**Agenda**  
**City of Charlevoix Zoning Board of Appeals Regular Meeting**  
**Wednesday, May 18, 2022 - 6:00 PM**  
**Council Chambers, 210 State Street, Charlevoix, MI**

## ZONING BOARD OF APPEALS STAFF REPORT

<b>AGENDA ITEM:</b>	<b><u>ZBA 22-02 Variance Request for 205 Bridge Street</u></b>
<b>PUBLIC MEETING DATE:</b>	May 18, 2022, 6:00 PM
<b>PRESENTED BY:</b>	Janet Koch, Zoning Administrator

**2**  
**A4**  
**PROPOSED BRIDGE ST. (FRONT) ELEVATION**  
 SCALE: 1/4"=1'-0"

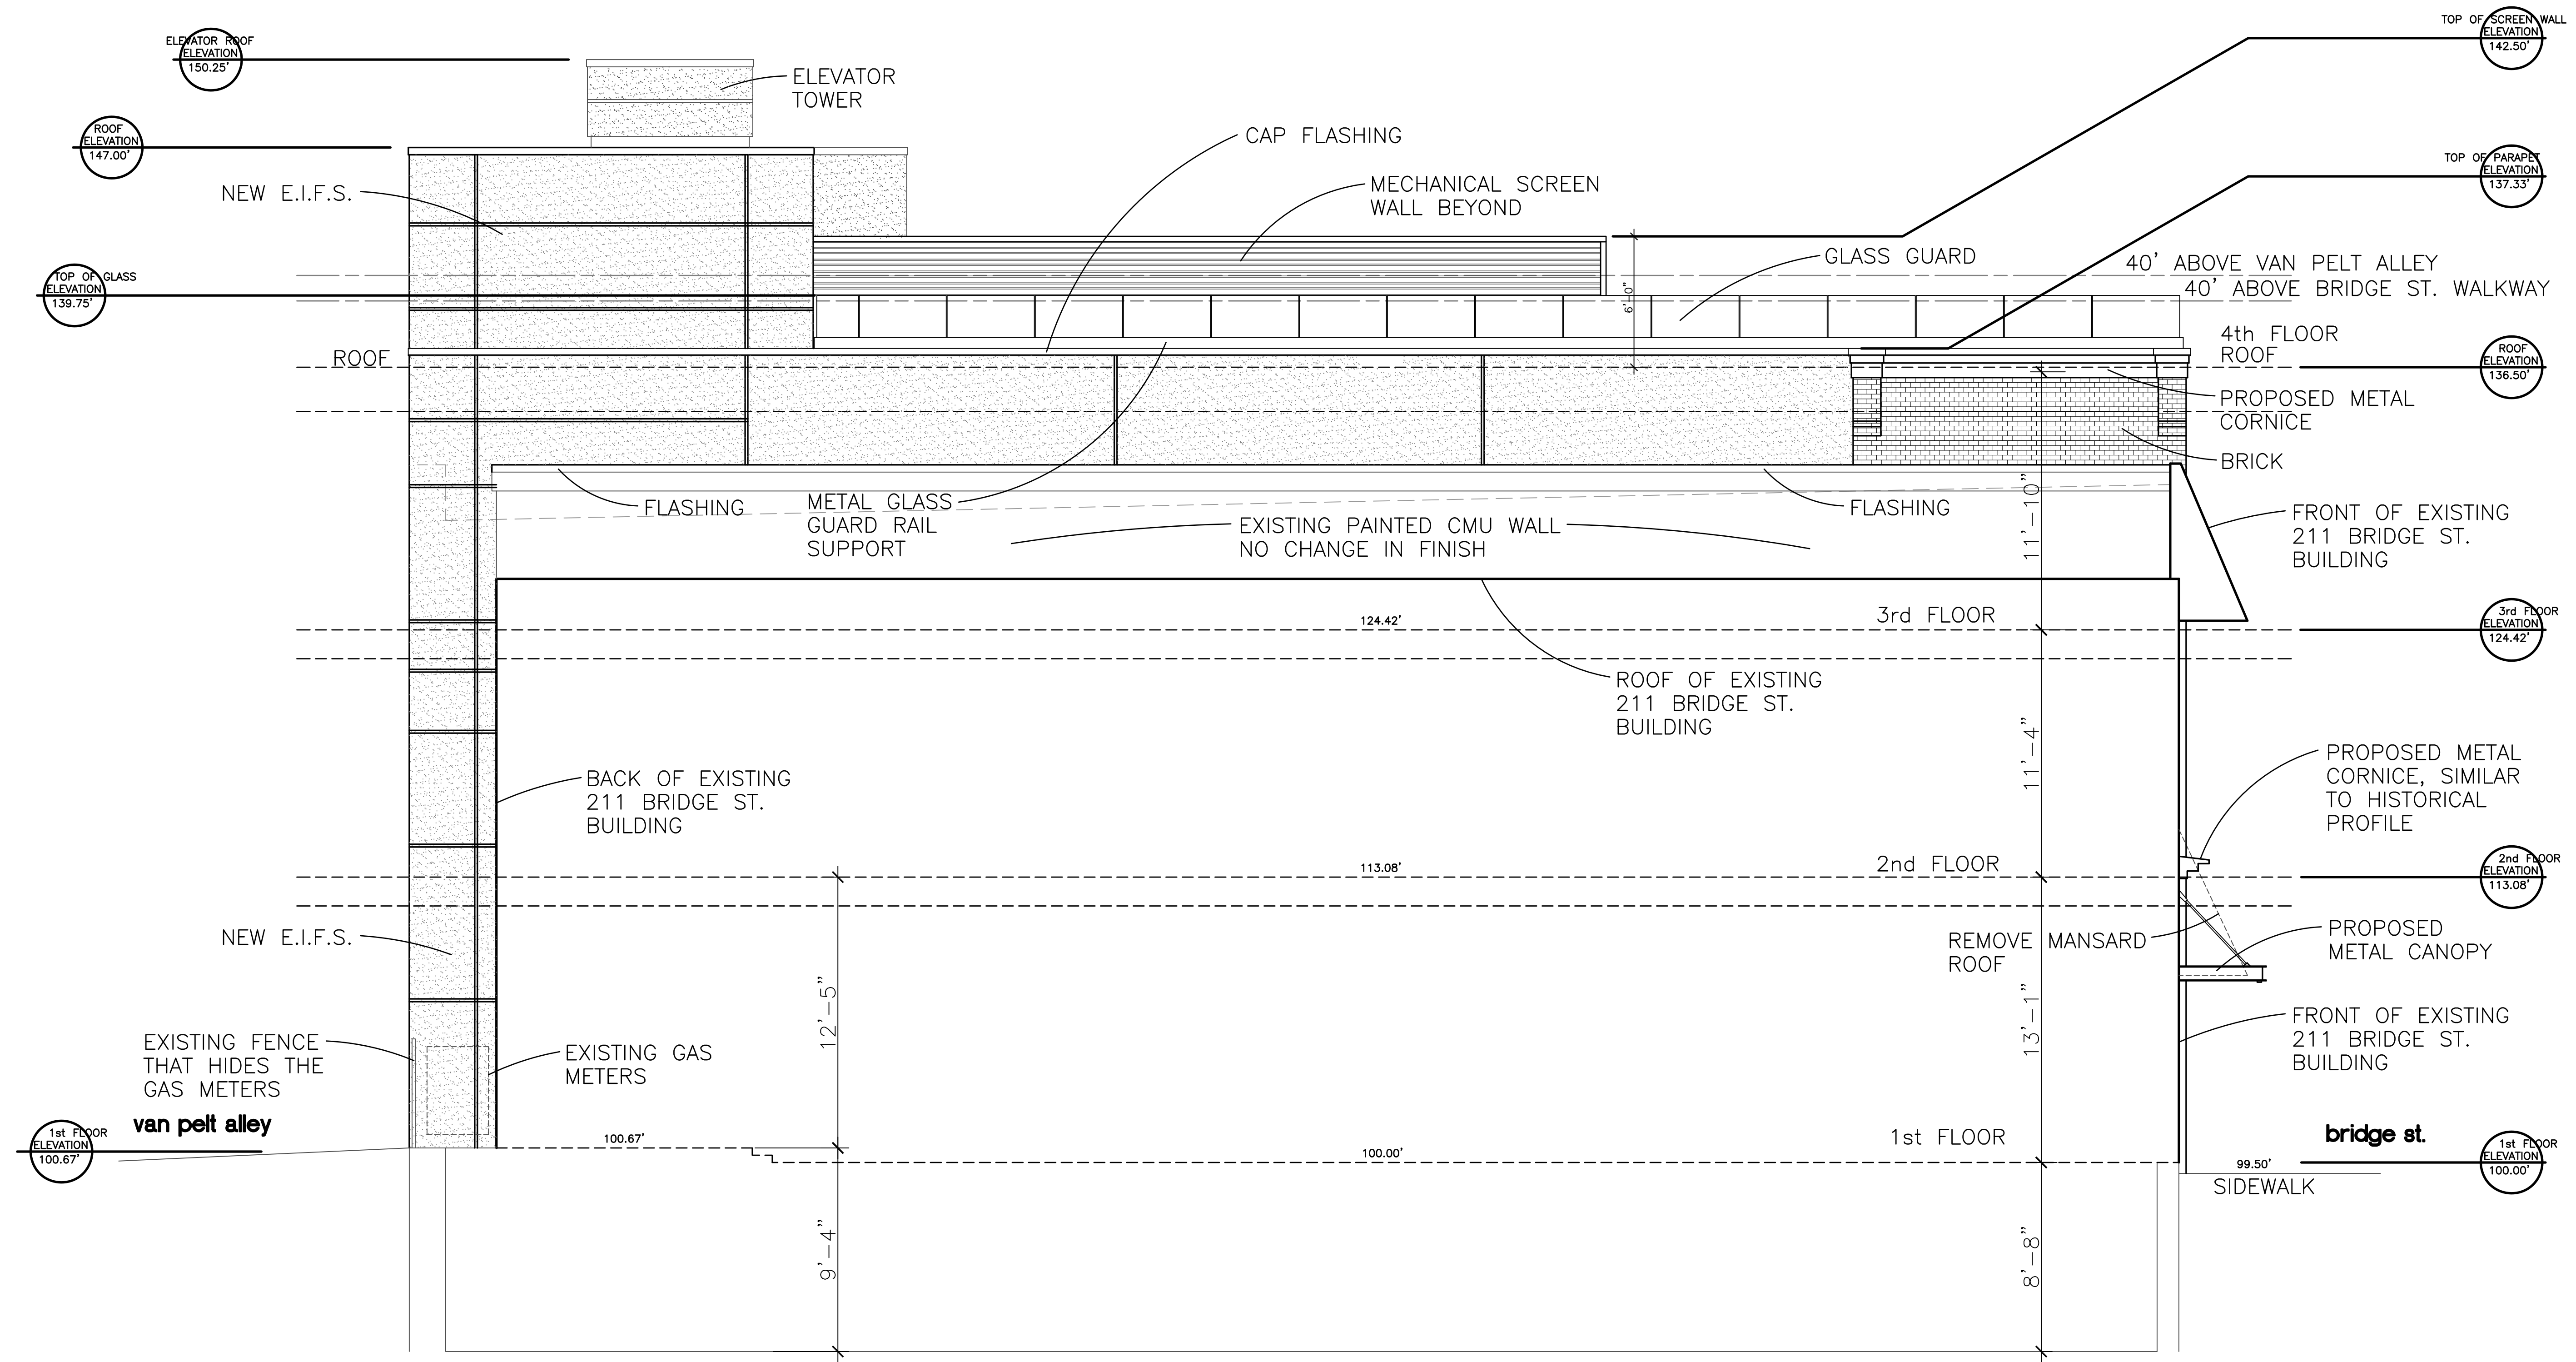
The site plan shows the proposed heights of the building and mechanical equipment. The applicant is requesting a variance to increase the height of the elevator and emergency staircases to 13.75 feet above the roof (shown on Sheets A4 and A5 of the architect plans). The top of the proposed elevator roof is at 150.25 feet. The plans illustrate a current roof elevation of 136.50 feet above the sidewalk elevation of 99.5 feet; this indicates a current building height of 37 feet.
